### REMARKS

Application No. 10/790,150  
Howard E. HUBER, Jr. et al.  
Annotated Sheet Showing Changes

FIG. 4

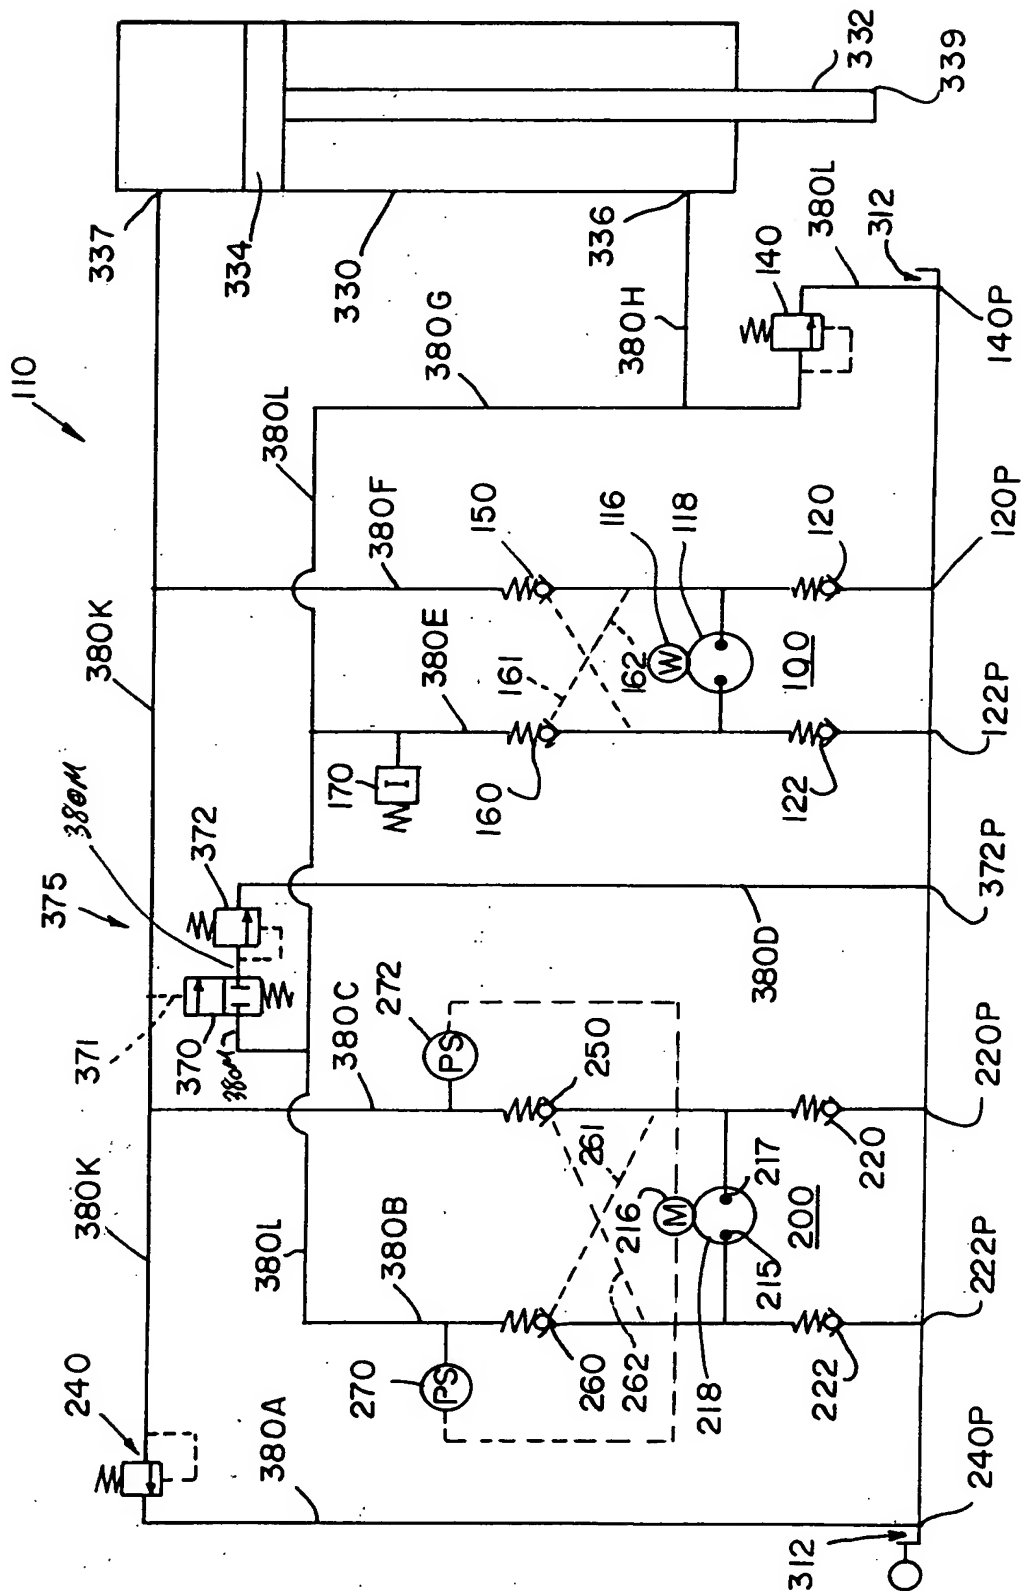
Figure 4 has been amended to include numerical description 380M, support which is found in paragraph 47 of the Specification. An Annotated Sheet and a Replacement Sheet are included herein.

Please note the enclosed Figure 4 marked as “Annotated Sheets”.
